Change of Country of origin on packaging label

Product Change Notification					PCN Cord retaining kit		
owner	creation date	release date	released by	change order no	rev	page	D10-032-730
huberth	13.12.2018	25.07.2019	limachcl	2016835	A	1 of 1

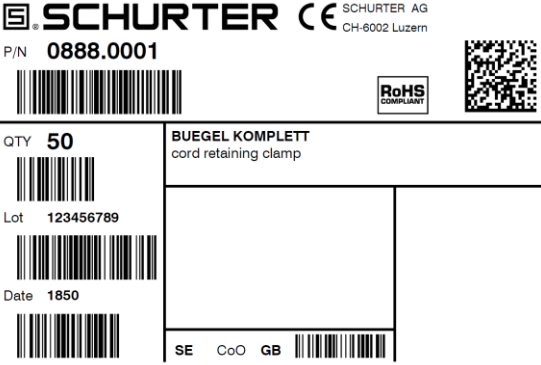
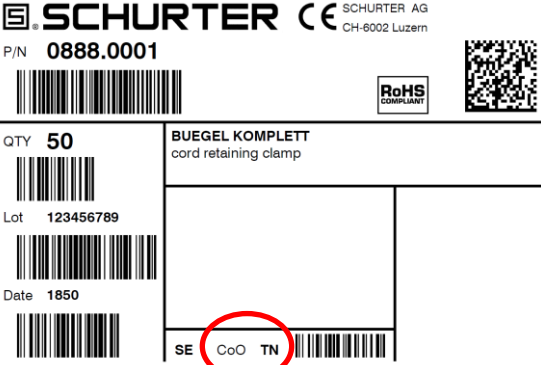
Country code for country of origin changed from GB to TN.
